AGN23001

RE: Pearce Farm
Case Number: CID-24-08
Response to 4th CD Review Comments
AGN23001

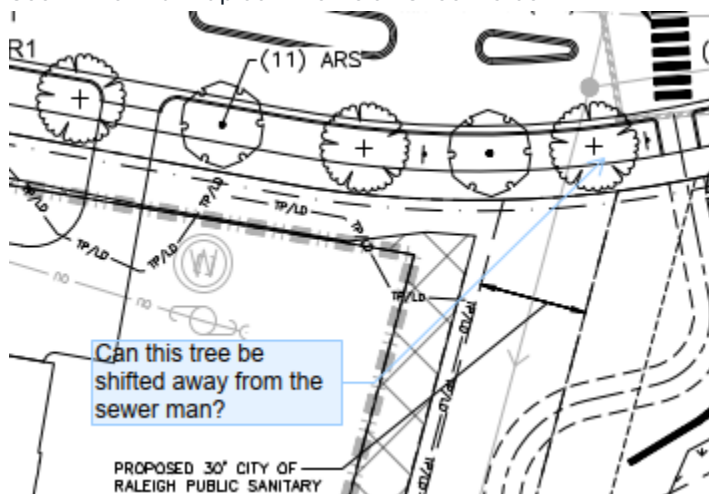
1. In light of the 7/1 email from John-Michael Henson, any deviation from the Zoning Conditions (Condition 10) must be reviewed by the Town Attorney. This latest proposal suggests NOT dedicating the land to the Town, which is deviating from MA 21-20 Condition #10 which states “approximately 4 acres of this parcel shall be dedicated to the Town as shown on the Concept Plan. “and that 4 acres is in the vicinity of the southwest quadrant of Pearce Farm Pond Drive and Greenway Hollow Drive, plan north of the SCM’s “G” and “B”.

McAdams Response: From language provided by Alliance Group to the Town on 08/28:

MA 21-20 CONDITION #10:

The first clause of Condition #10 of MA 21-20 (“At the time of the recording of the first plat adjoining any portion of 2017 Forestville Road (Wake PIN: 174-869-4159), approximately 4 acres of this parcel shall be dedicated to the Town as shown on the Concept Plan...”) shall be fulfilled as follows:

The term “dedicate” shall be understood to indicate the dedication of an easement in favor of the Town of Rolesville, depicted on the first final subdivision plat for parcel referenced in the aforementioned zoning condition.

The easement shall:

- i. Encompass all of the area shown as the “Active Recreation Features” labeled “Public Trailhead” on PSP-23-04
- ii. Permit Town of Rolesville to access and maintain the greenway trailhead park if and/or when it elects to do so.
- iii. Permit lawful public enjoyment by the residents of the Town of Rolesville of the greenway trailhead park at any time after its completion.
- iv. Contain any further provisions as may be prescribed in a development agreement
